ORDINANCE NO. 06-39 AC CMS

AN ORDINANCE AMENDING ORDINANCE NO. 04-12 AC CMS THAT ACCEPTED THE BID OF NERONE & SONS., OF WARRENSVILLE HEIGHTS, OHIO, FOR IMPROVEMENTS TO THE EQUALIZATION BASIN AT THE CITY OF OBERLIN WATER ENVIRONMENT PROTECTION FACILITY AND DECLARING AN EMERGENCY

Subject: Oberlin Old EQ Basin Improvements Contract – Change Order 2 - Items 2.1 through 2.9 (Nerone & Sons, Inc.)

MEASUREMENT AND PAYMENT – CHANGE ORDER 2 – NEW EQ BASIN WORK

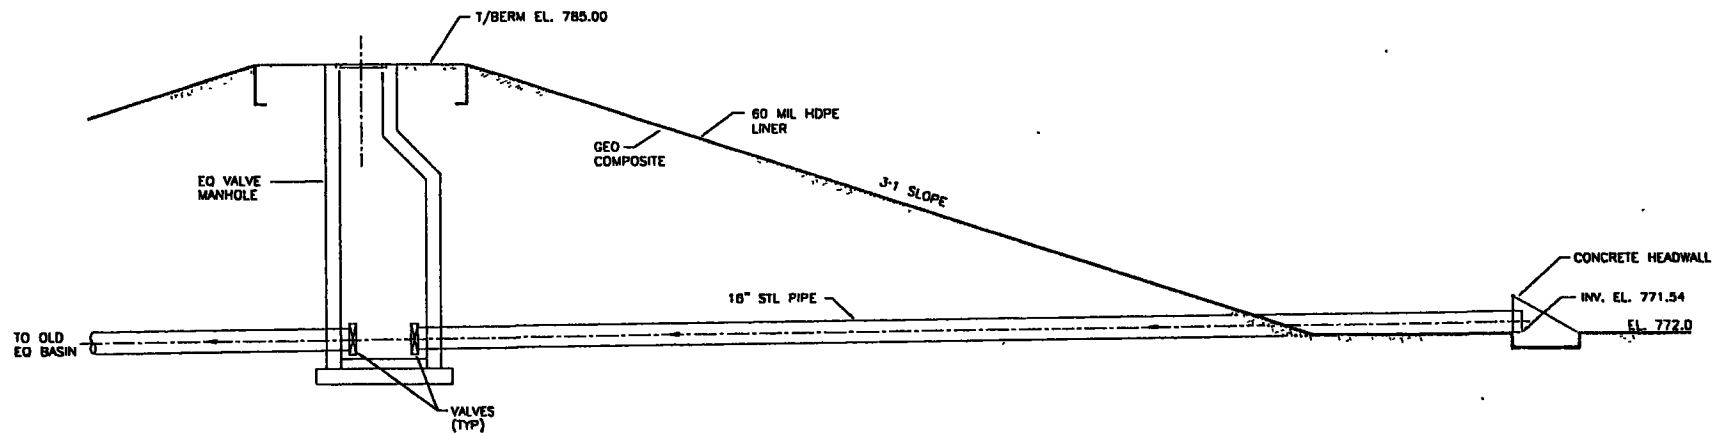
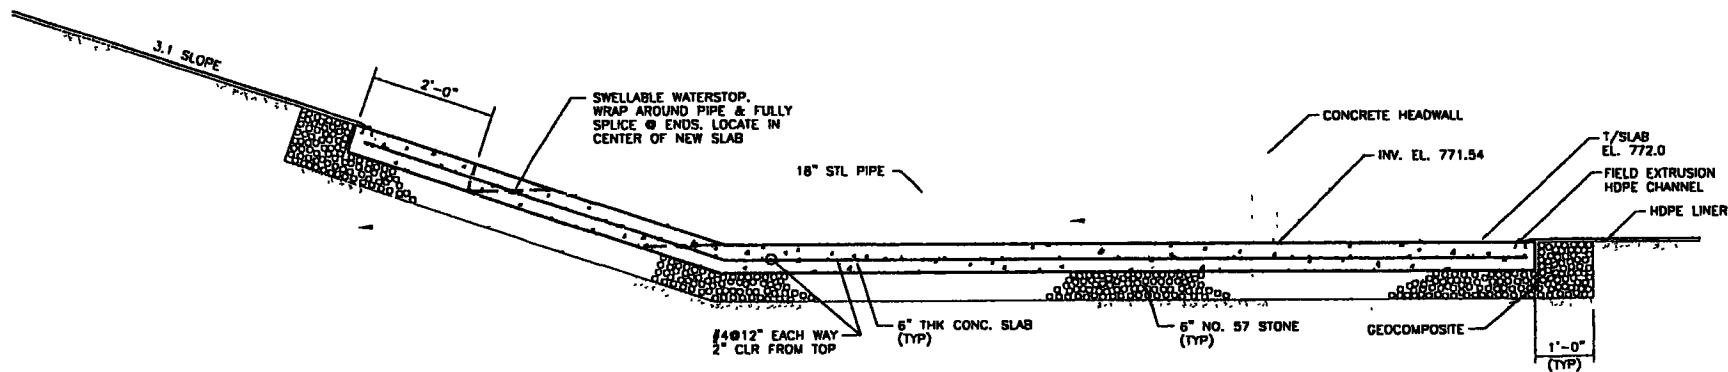
2.3 – Underground Void Grouting (Bid Item 2) – A hole in the bottom of the existing EQ basin manhole has caused soil erosion around the manhole. The cost for this item will cover pumping grout into the void to provide stability and reduce the risk of sinkholes. The cost for this item is \$15,600.00.

2.4 – Manhole Re-Lining (Bid Item 3) – The EQ manhole between the New and Old EQ Basins has a hole in the bottom and suspect leaky joints between the concrete manhole sections. This item will cover plugging the hole and lining the manhole with a durable sealant. **The cost for this item is \$5,445.00.**

2.7 – Concrete Slab (Bid Item 6) – A concrete slab is needed to support the concrete headwall in the New EQ Basin that is sinking due to soil erosion beneath the liner. The surrounding liner will be connected to the concrete slab by welding it to an embedded plastic channel within the slab. **The cost for this item is \$17,156.25.**

2.8 – Grout Fill Void Beneath Liner (Bid Item 7) – Soil erosion beneath the liner has created a void along the slope of the New EQ Basin adjacent to the EQ manhole. The void needs to be filled to stop erosion and prevent the risk of compromising the liner's integrity. **The cost for this item is \$3,937.50.**
